Project
 Adaptation and Refurbishments

Drawing Title:
Ground Floor Layout
As Approved Planning Certificate

Drawing Number:
 BR-09-1013-05

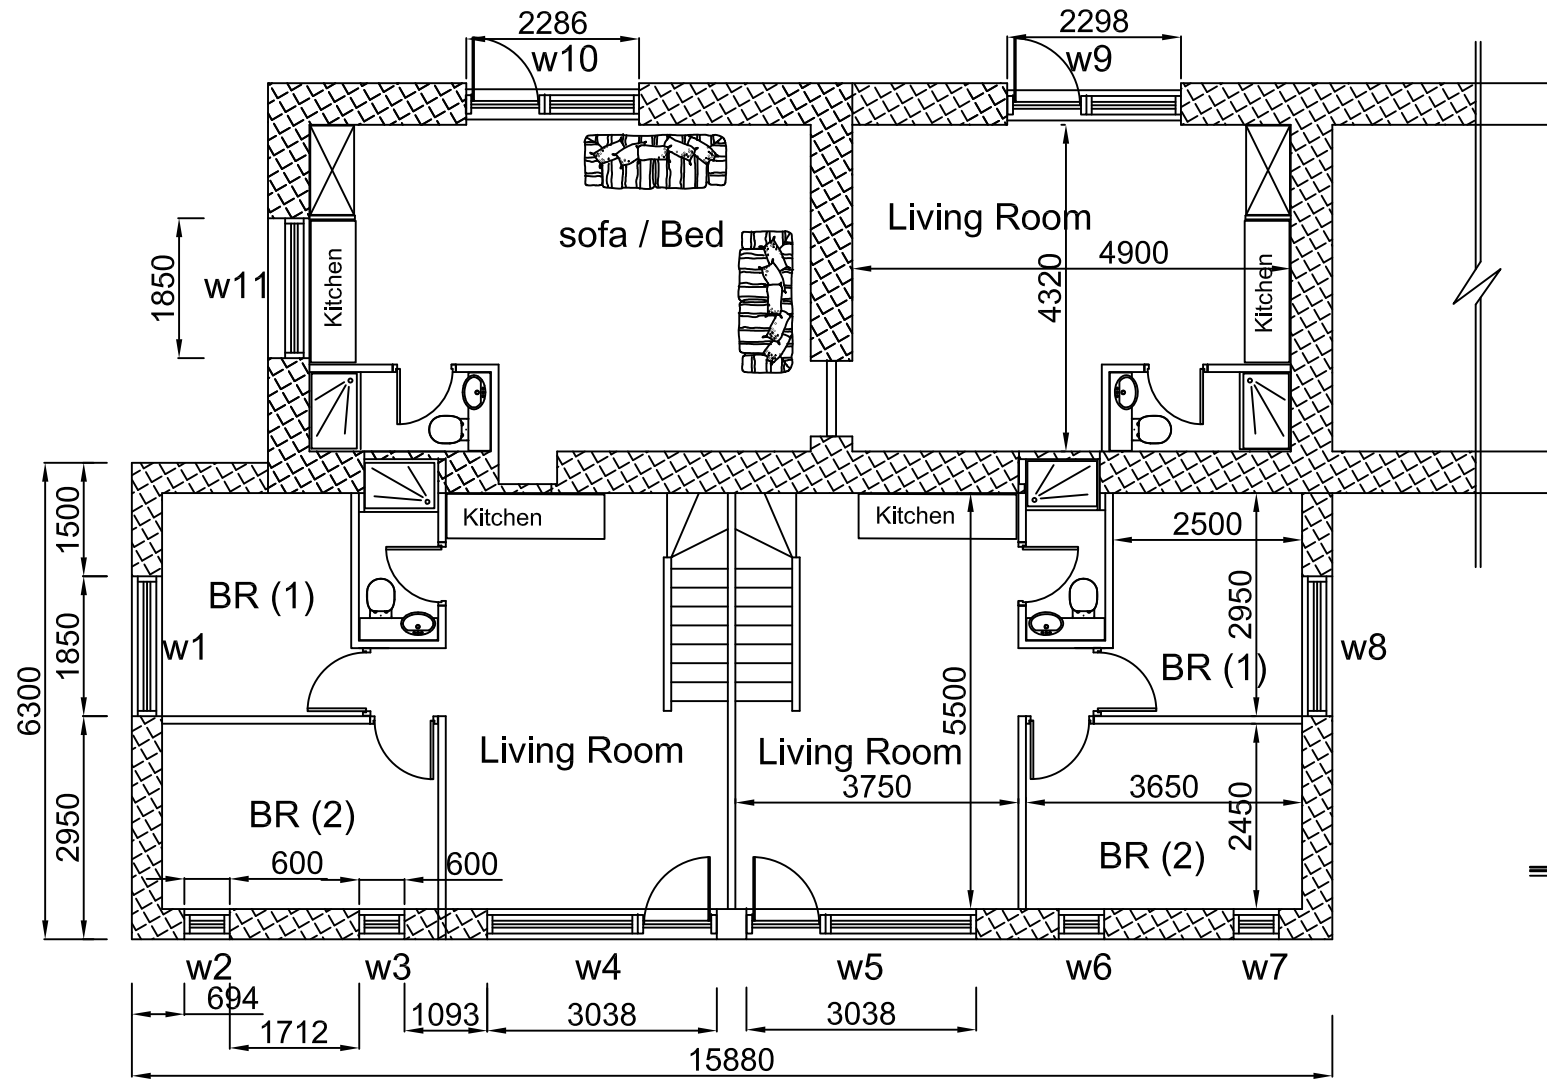
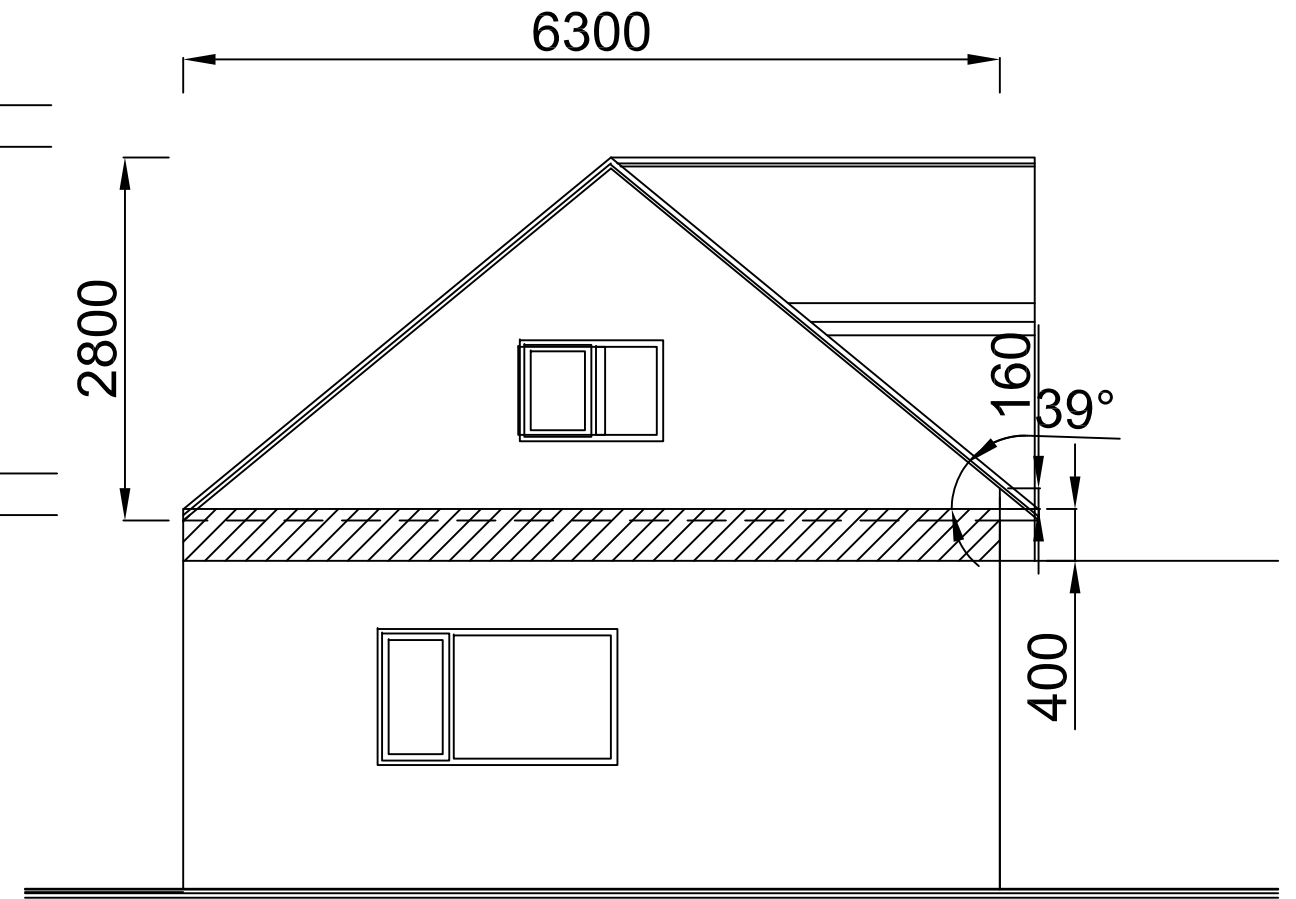
These door and windows, top should be 2250mm from existing concrete floor. (this is from concrete to underside of new Lintel)
